Appeal of the Planning Manager Decision approving permits for:

to allow the proposed road improvements to Willamette Falls Drive, including the roundabout, to be developed on riparian land in Fields Bridge Park and right of way.

AP-23-02

Karie Oakes and Teri Cummings

SHEET NUMBER
L1002

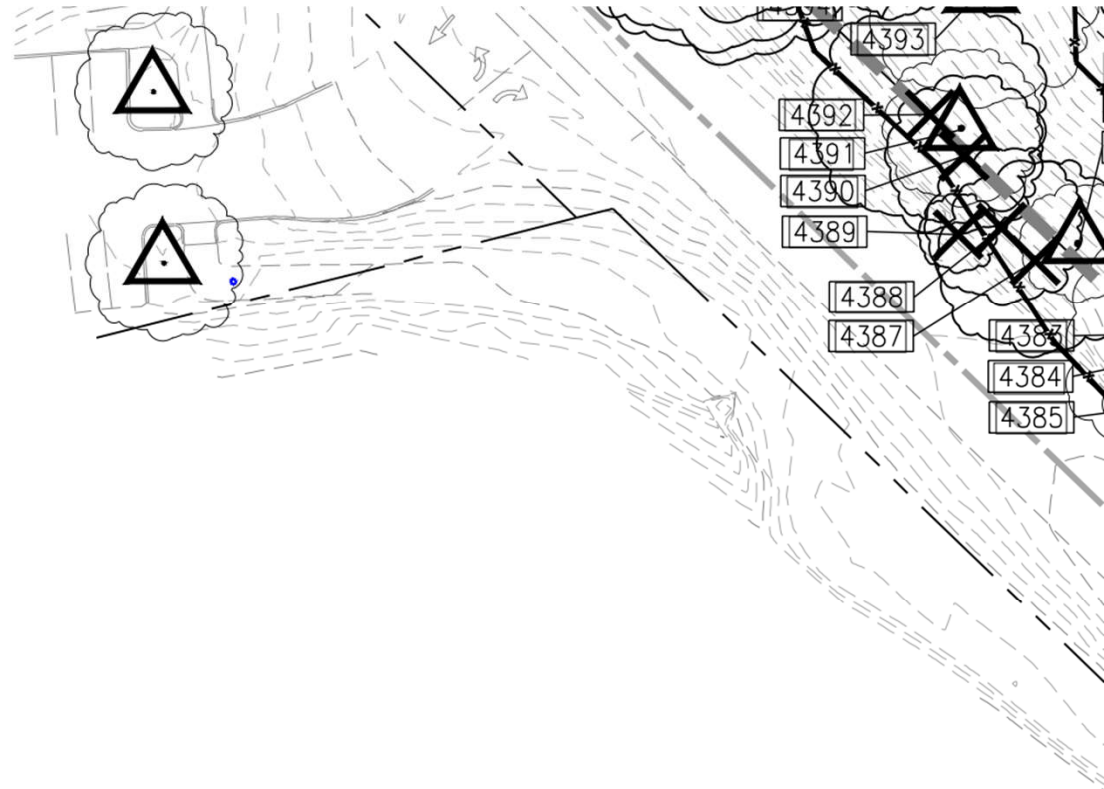
A disclaimer in the General note on the New Athey Creek Middle School Tree Protection Plan project sheets L1001 and L1002, dated May 17, 2021, states in General Note 3: **TREES WEST OF WILLAMETTE FALLS DRIVE SHOWN FOR REFERENCE ONLY AND NOT PART OF THIS LAND USE SUBMITTAL.**

Thus, there was no removal/protection plan in place before the City allowed at least 41 trees to be cut down in Fields Bridge Park.

Site Plan **FIGURE 6G**

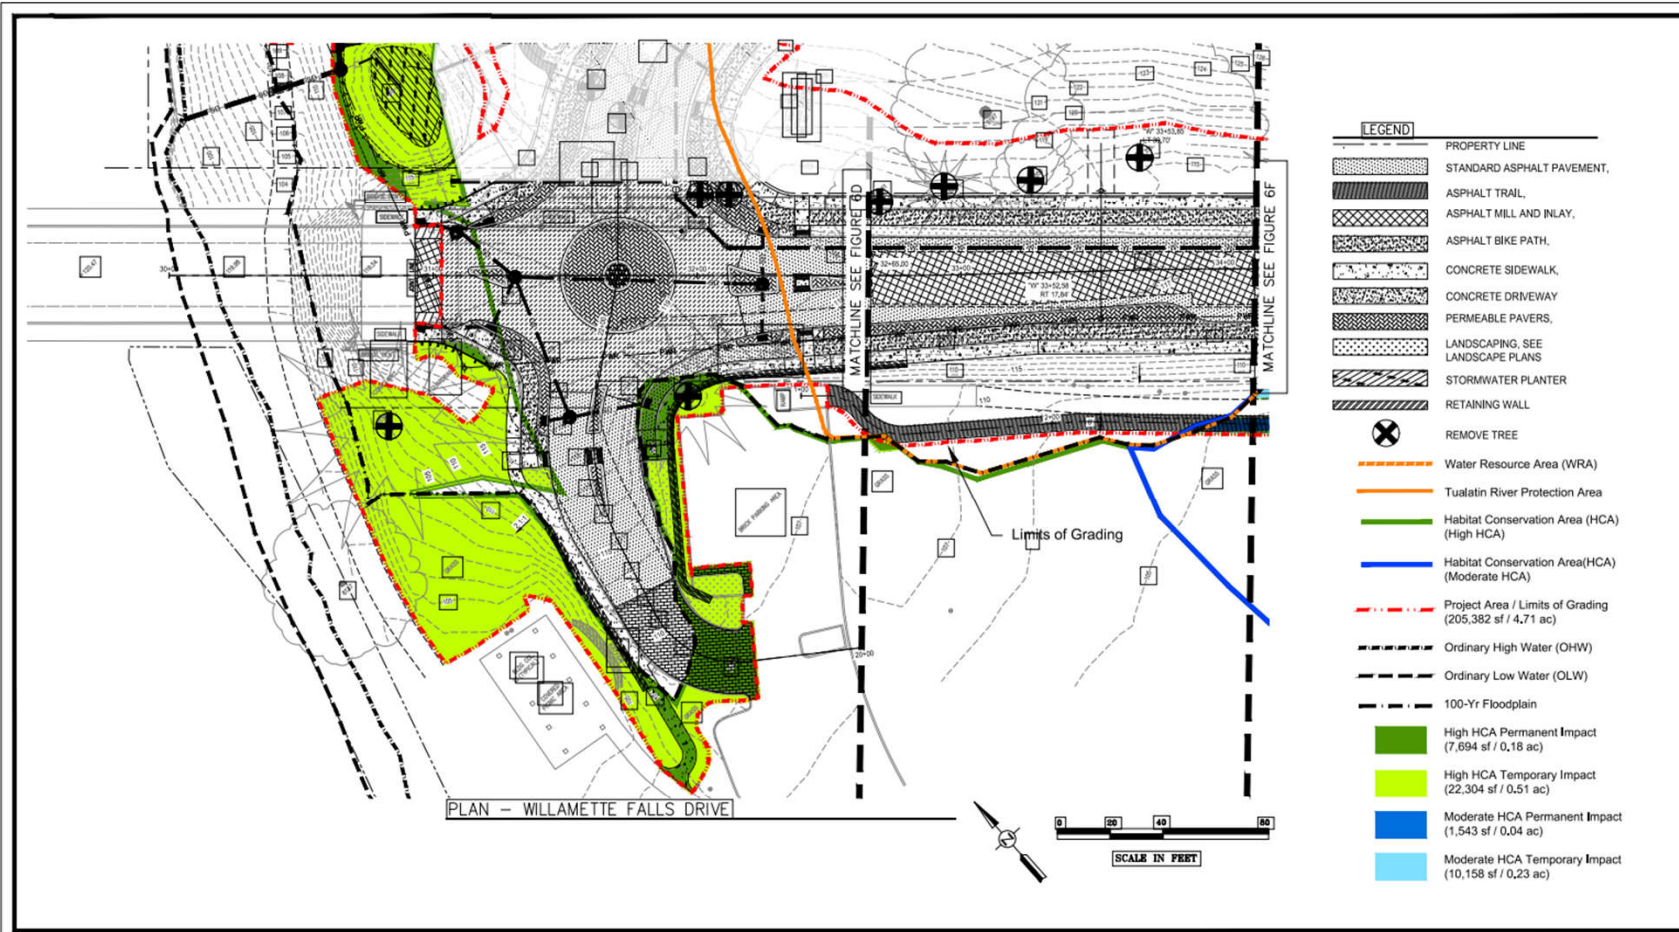
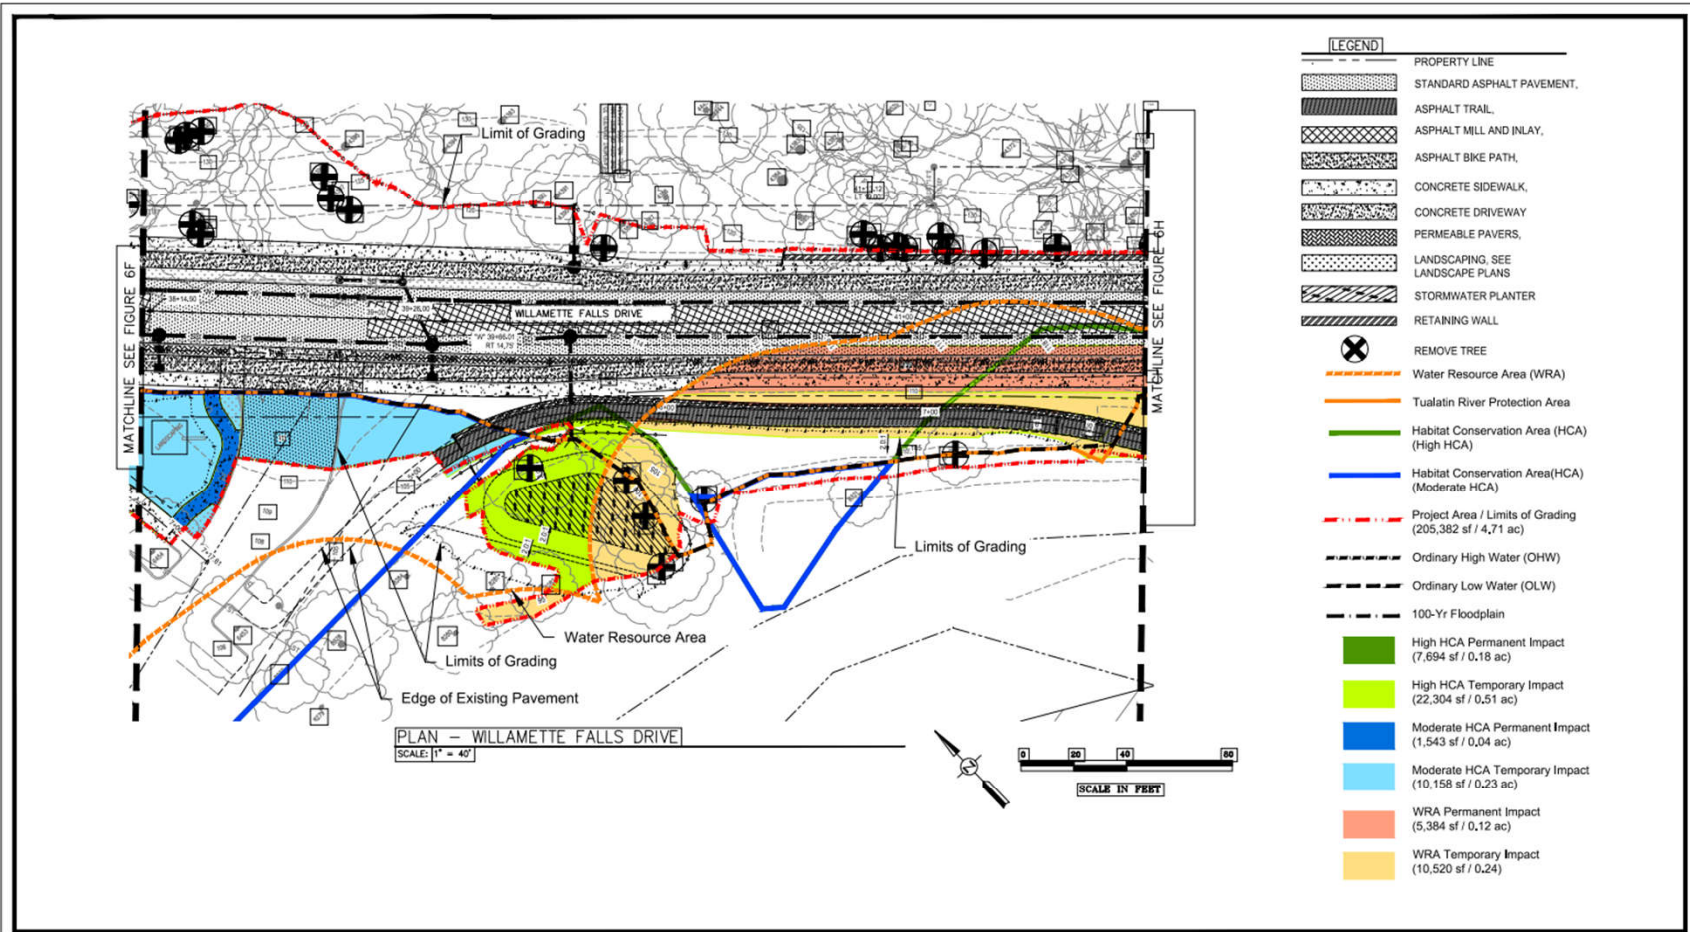
24 of the 41 trees were within the Tualatin River Protection Area, Water Resource Area or Flood Management Area.

See Figures 6E, 6G following and 6H, 6I previously shown.

CDC 28.110.U.3 was not met because the City did not protect the trees prior to obtaining the required permits.

FIGURE
10

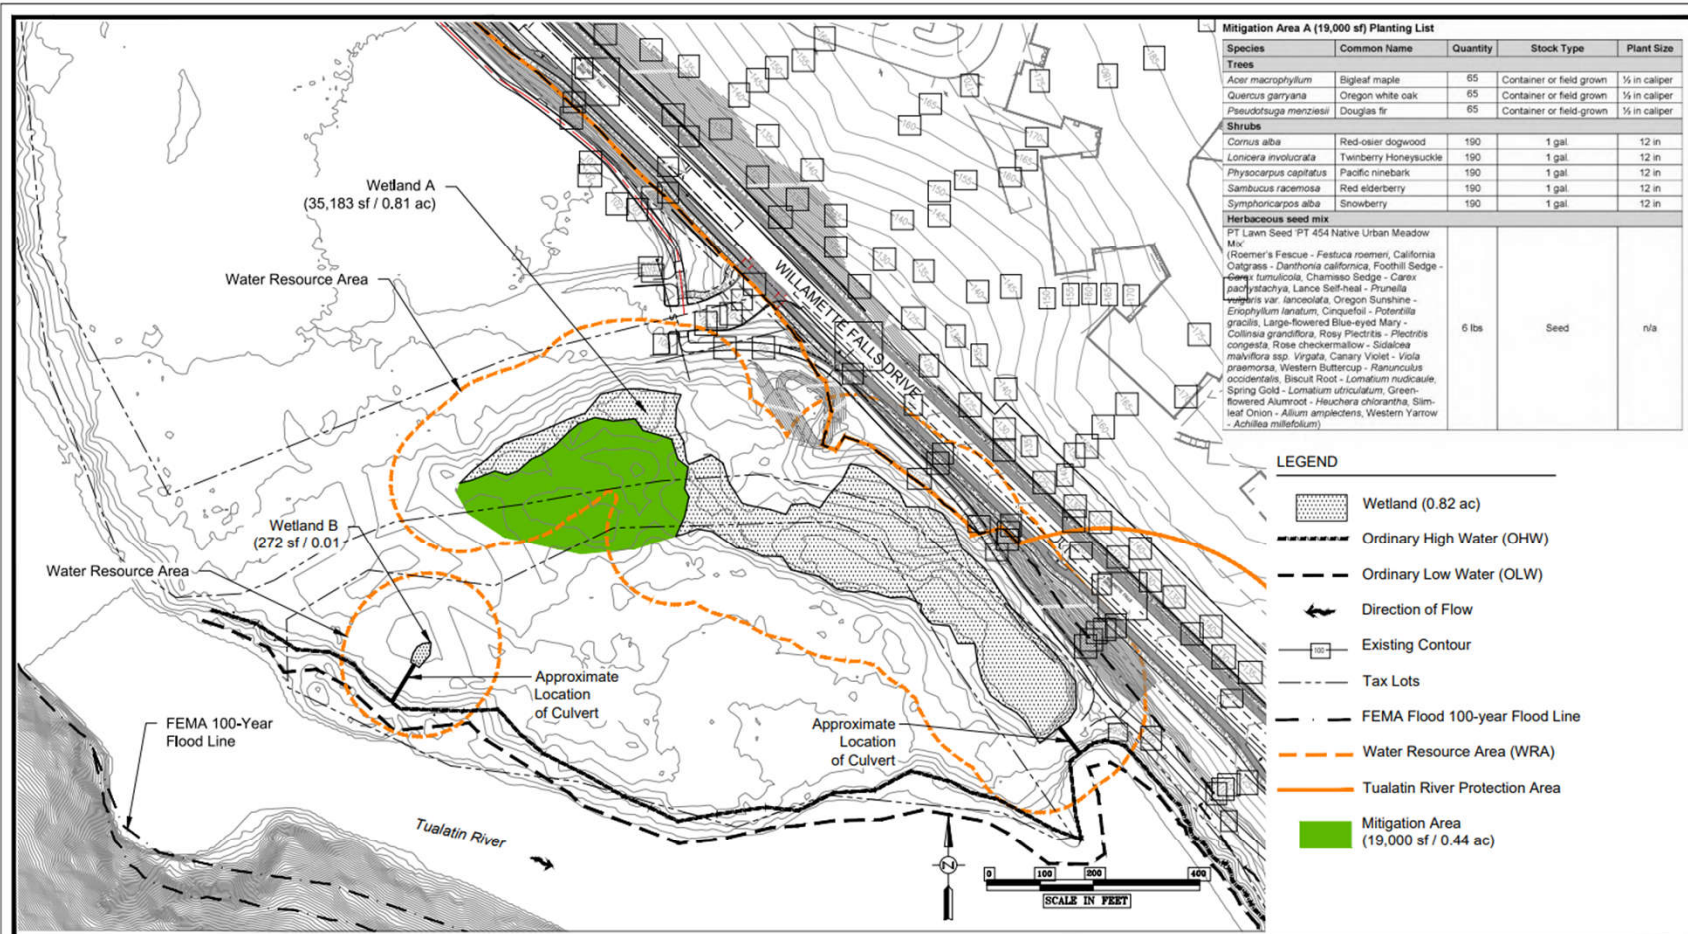
The Mitigation Plan Figure 10, dated 02/20/23, indicates that 195 trees, 950 shrubs and 6 lbs. of seed will be planted on 19,000 sq ft (.44acre) in Wetland A, but does not show where these things will be planted.

The planting list for the Mitigation Area (.44 acre) does not appear to be a feasible plan due to the potential mature size of the 195 trees plus 950 shrubs and 6# of seed.

The planting list includes 65 Maple trees, 65 White Oak trees and 65 Douglas Fir trees, of which the White Oak and Douglas Fir trees which might not be appropriate for a wetland.

FIGURE 9C

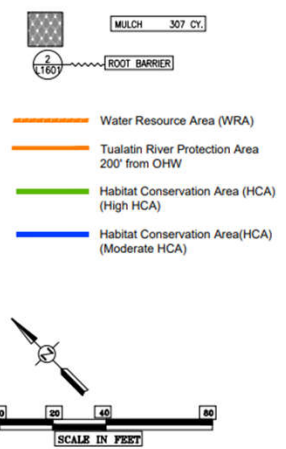
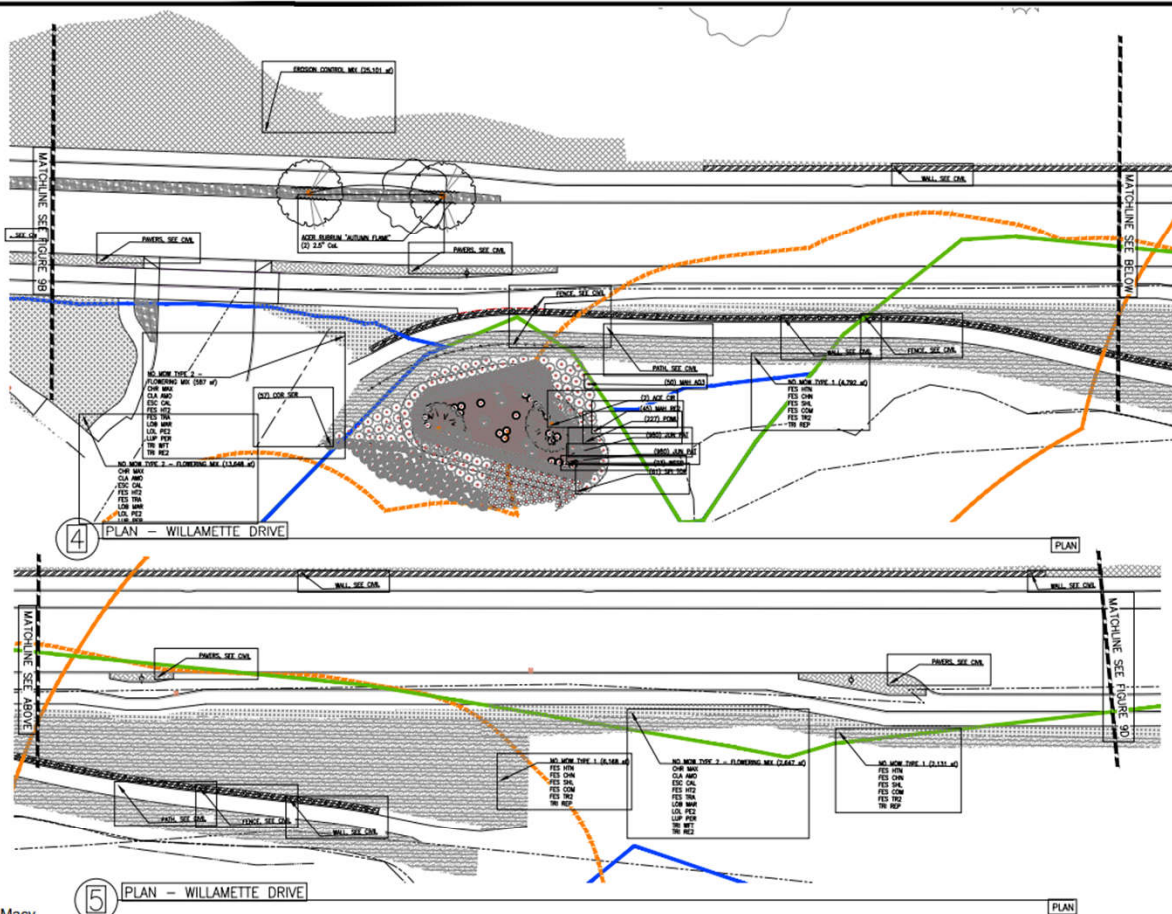
The Planting Plan Overview Sheet Index Figure 9C, dated 12/21/22, clearly indicates where two maple trees and other vegetation will be planted but this is not located in the mitigation area shown in Figure 10.

There is a huge difference between the details in these two plans. We would like an explanation as to why they do not seem to coincide.

The application does not meet the submittal requirements of CDC 28.090.C.5 Landscape Plan and CDC 28.090.C.6 Mitigation Plan.
